ADC Telecommunications				A0		20028104		5/17/99		LRT			
								REV		ECO		DATE		APV			
APV		THIS PRINT IS THE PROPERTY OF ADC, IT SHALL NOT BE COPIED WITHOUT PERMISSION.				TITLE SCH, SINGLE STAGE AMPLIFIER ASSY., CLASS A, MID BAND (1265-1416)											
DATE		MATERIAL -----															
ECO		FINISH -----				DWN		GK		1/29/96		DWG. NO. 1265-3416				REV B0	
REV						REL		JAG		3/19/96		C		SCALE ---		SHEET 1 OF 1

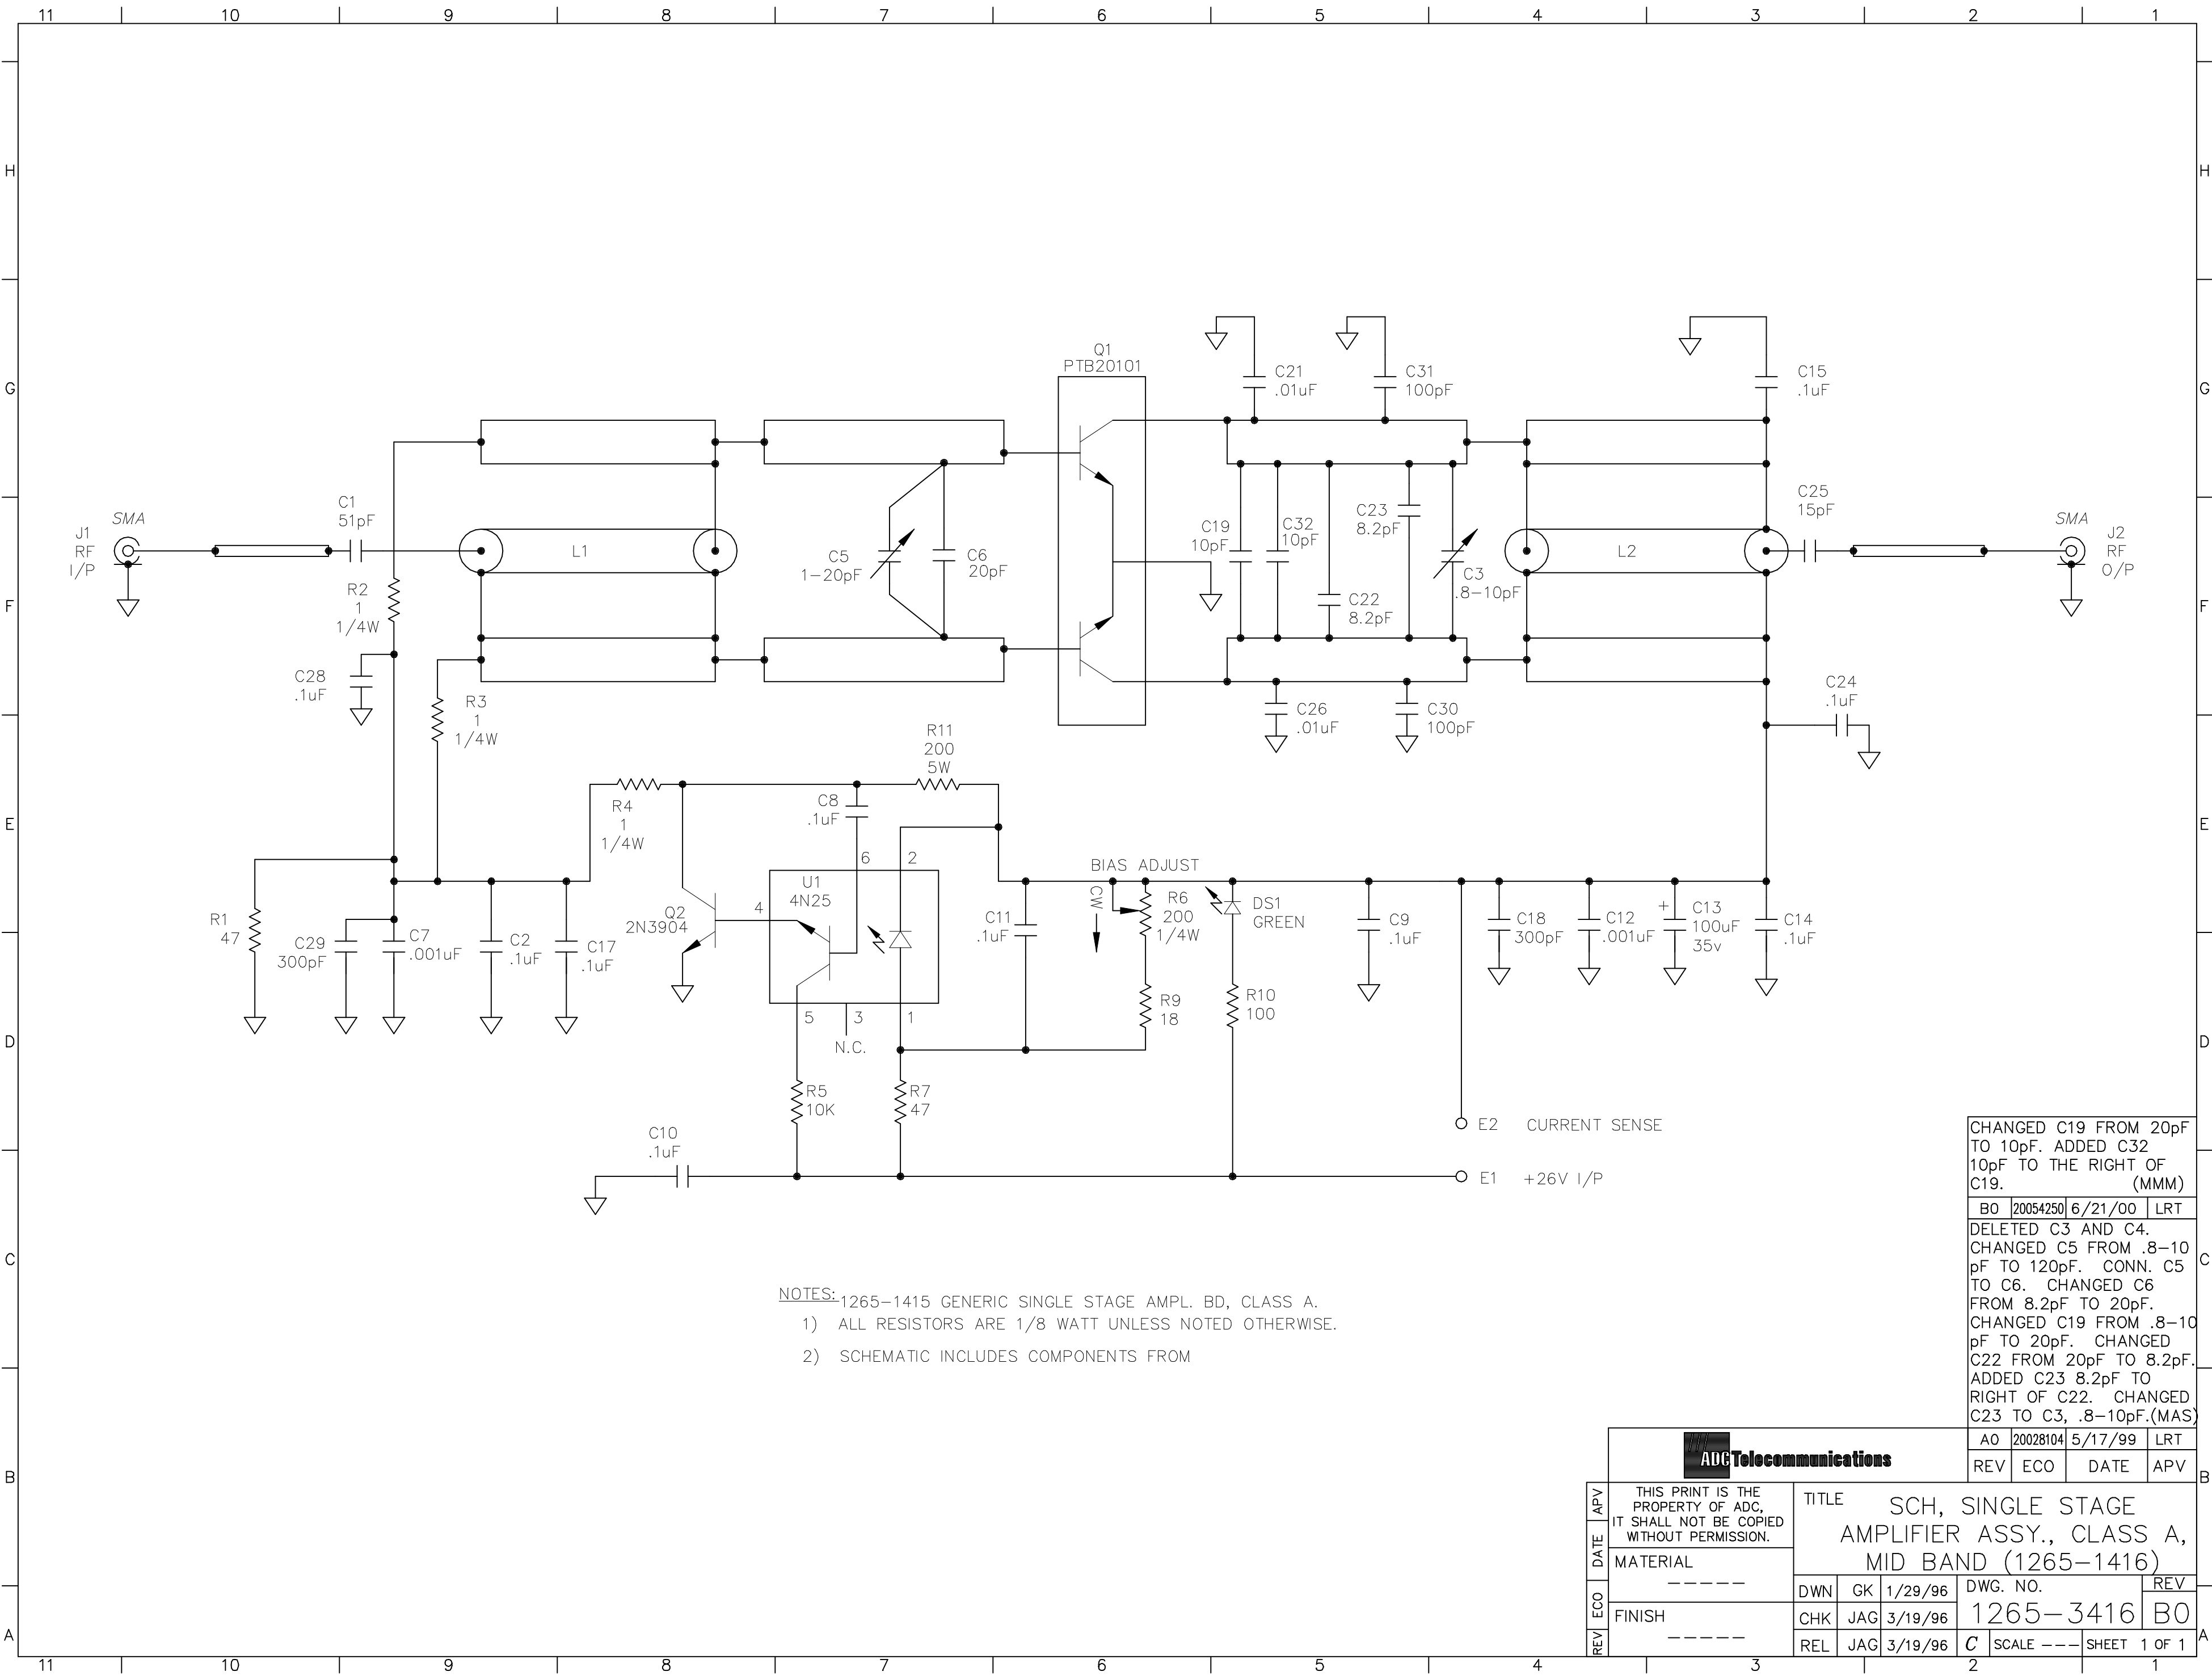
CHANGED C19 FROM 20pF TO 10pF. ADDED C32 10pF TO THE RIGHT OF C19. (MMM)
B0 20054250 6/21/00 LRT
DELETED C3 AND C4. CHANGED C5 FROM .8-10 pF TO 120pF. CONN. C5 TO C6. CHANGED C6 FROM 8.2pF TO 20pF. CHANGED C19 FROM .8-10 pF TO 20pF. CHANGED C22 FROM 20pF TO 8.2pF. ADDED C23 8.2pF TO RIGHT OF C22. CHANGED C23 TO C3, .8-10pF.(MAS)
